Environmental Protection Act 1986

**NOTICE OF DECISION TO CONSENT TO AMEND A REFERRED PROPOSAL
DURING ASSESSMENT**

West Angelas Revised Proposal
Assessment No. 2290

Attachment 1- Amended proposal content document and figures showing the new approved proposal

Figure 1-1: Proposed Amendments to the Development Envelope

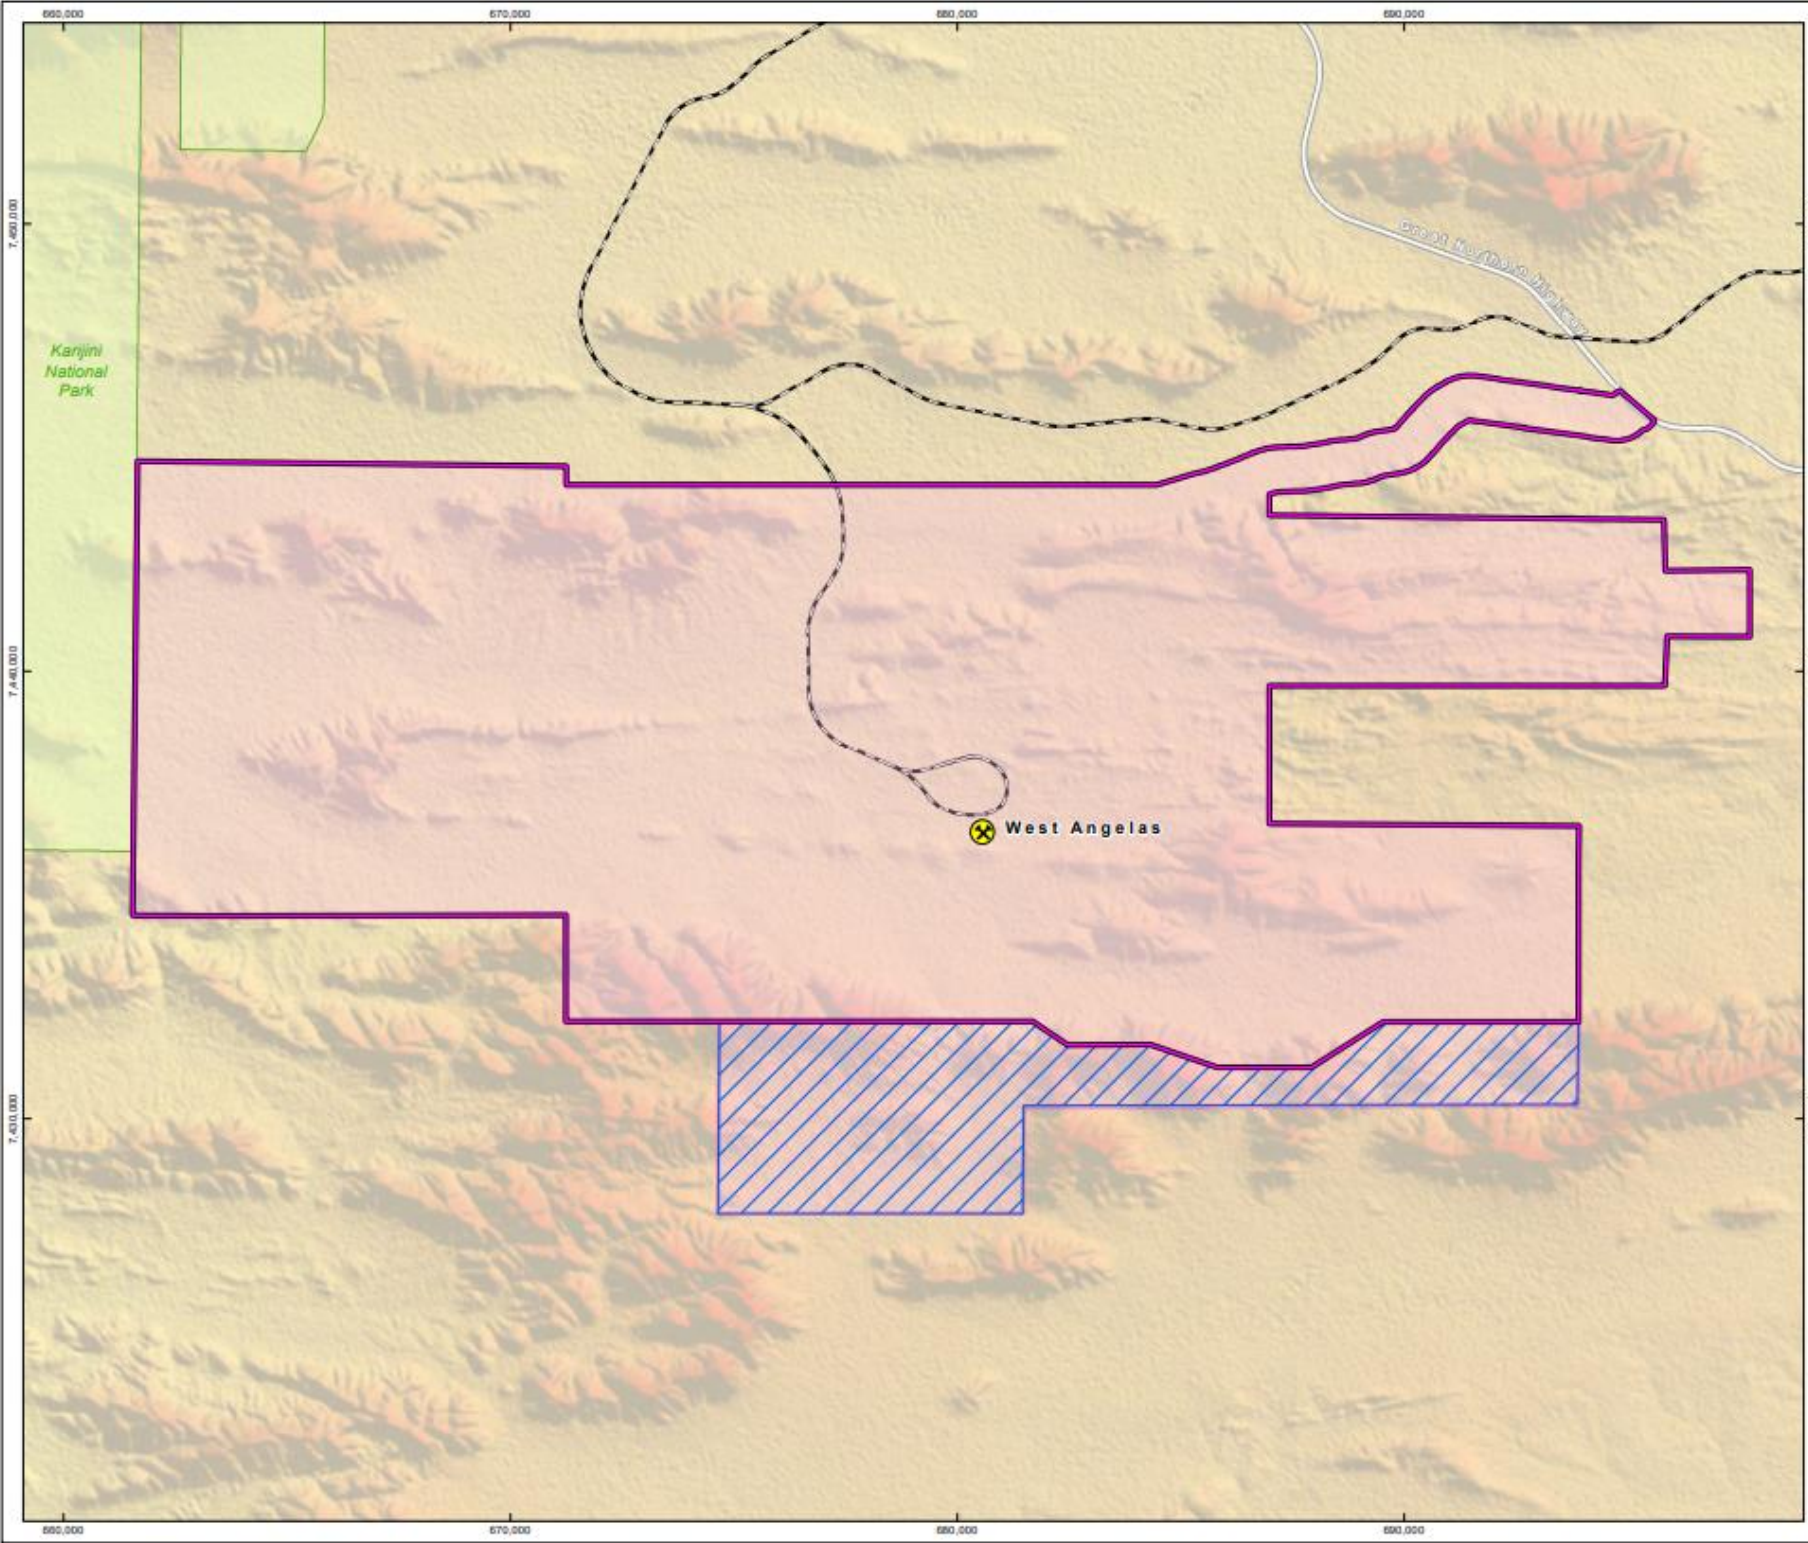
- A reduction in the total area of the Development Envelope (DE) by 4,705 hectares (ha) to 36,779 ha.
- A reduction to the total clearing extent by 1,805 ha to 17, 555 ha.
- Addition of solar renewable energy generation, storage, and associated infrastructure.
- Redesign proposed pits and associated waste landforms at the Mount Ella East deposit to limit southern extent.
- Removal of tailings storage facility (TSF) proposed at Deposit J.
- Amendments to update proposal description in relation to the above changes.

- a reduction to the DE by 4,705 ha
- a reduction to the clearing extent by 1,805 ha
- inclusion of renewable energy generation and storage options
- removal of tailings storage facility at Deposit J
- updated proposal description.

Figure 1: Proposed change to development envelope

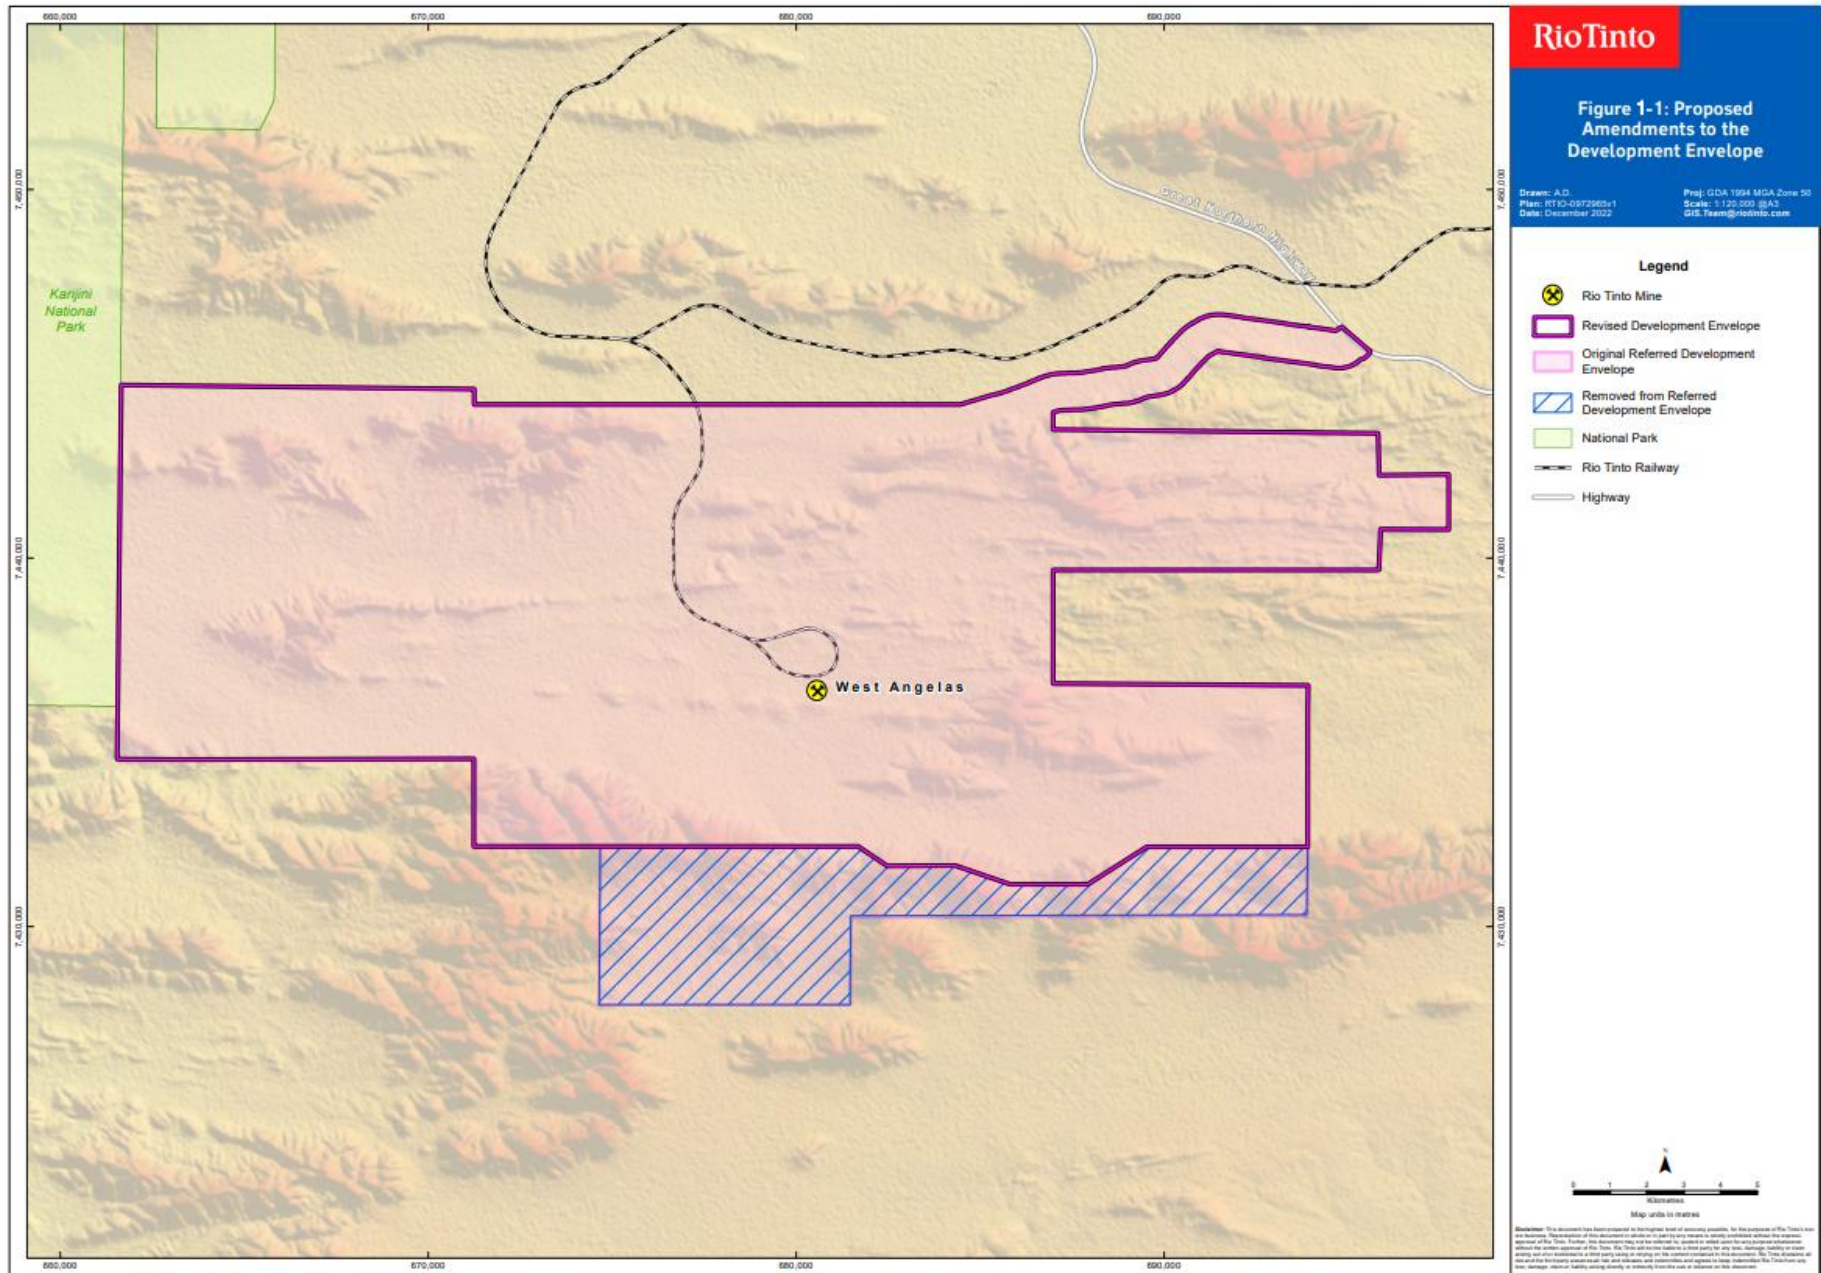
Proposed amendments to the development envelope and key proposal elements are displayed in Figures 1 and 2.

Amendment sought	Changes to environmental impacts
<p>Change to DE:</p> <ul style="list-style-type: none"> - reduction in size by 4705 ha 	<p>The proposed amendment will likely result in:</p> <ul style="list-style-type: none"> • reduced impacts to Social Surroundings Aboriginal Heritage values by avoiding direct impacts and minimising indirect impacts to culturally significant landforms. • reducing impacts to critical habitat by avoiding 3,269 ha of Gorge/Gully for conservation significant fauna including: <ul style="list-style-type: none"> ○ northern quoll ○ ghost bat ○ Pilbara olive python • avoid direct impacts to 1,363 ha of supporting habitat (for foraging and dispersal) for Matters of National Environmental Significance (MNES) species. • reduce potential clearing of vegetation communities with high local significance, including 108 ha of riparian vegetation and 1,700 ha of vegetation type H15. • avoidance of direct impacts to 7 caves utilised by ghost bats including: <ul style="list-style-type: none"> ○ one category 2 (maternity/diurnal roost cave with regular occupancy) ○ one category 3 (diurnal roost cave with occasional occupancy) ○ 5 category 4 roosts (nocturnal roost caves with opportunistic usage). <p>The proposed change is unlikely to increase or introduce additional impacts. The environmental outcomes may improve compared to the original proposal and increase the likelihood of remaining consistent with EPA objectives.</p>
